UNITED STATES PATENT AND TRADEMARK OFFICE

APPLICATION NO.	FILING DATE	FIRST NAMED INVENTOR	ATTORNEY DOCKET NO.	CONFIRMATION NO.
10/540,085	10/14/2005	Per-Ingvar Branemark	2816-3	6431
616 7590 03/30/2007 THE MAXHAM FIRM 9330 SCRANTON ROAD, SUITE 350 SAN DIEGO, CA 92121			EXAMINER WOODALL, NICHOLAS W	
			ART UNIT	PAPER NUMBER
			3733	
SHORTENED STATUTORY PERIOD OF RESPONSE		MAIL DATE	DELIVERY MODE	
3 MONTHS		03/30/2007	PAPER

Office Action Summary

DETAILED ACTION

Figure 1

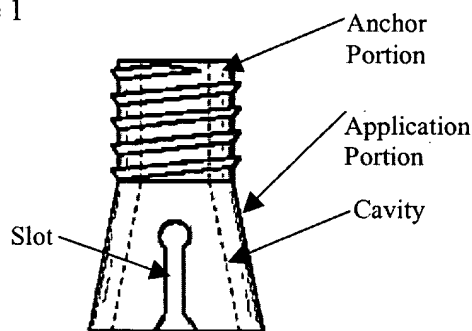
Regarding claim 13, Errico discloses a device comprising an anchoring portion and an application portion. The application portion has an outer end and an end connected to the anchoring portion. The application portion has a flared out portion that widens from the end connected to the anchoring portion towards the outer end. The flared portion is elastically resilient in a direction transverse to the longitudinal direction of the device. Regarding claim 14, Errico further discloses the flared out portion is formed of an outer wall surrounding a cavity that is open towards the outer end of the application portion. The flared portion also contains slots penetrating through the outer wall that connect the cavity with the outside of the outer wall. Regarding claims 15 and 16, Errico further discloses the anchor portion includes a threaded part and the flared portion has a rotationally symmetrical outer contour around the center axis defined by the threaded part. Regarding claims 17 and 18, Errico further discloses the flared portion to have a truncated cone shape. Regarding claim 23, Errico further discloses the slots define an angle of 90 degrees with the radius of the truncated cone. With regard to the statement of intended use and other functional statements, they do not impose any structural limitations on the claims distinguishable over Errico, which is capable of being used as claimed if one so desires to do so. *In re Casey*, 152 USPQ 235 (CCPA 1967) and *In re Otto*, 136 USPQ 458, 459 (CCPA 1963). Furthermore, the law of anticipation does not require that the reference "teach" what the subject patent teaches, but rather it is only necessary that the claims under attack "read on" something in the reference.

Kalman v. Kimberly Clark Corp., 218 USPQ 781 (CCPA 1983). Furthermore, the manner in which a device is intended to be employed does not differentiate the claimed apparatus from prior art apparatus satisfying the claimed structural limitations. Ex parte Masham, 2 USPQ2d 1647 (1987).
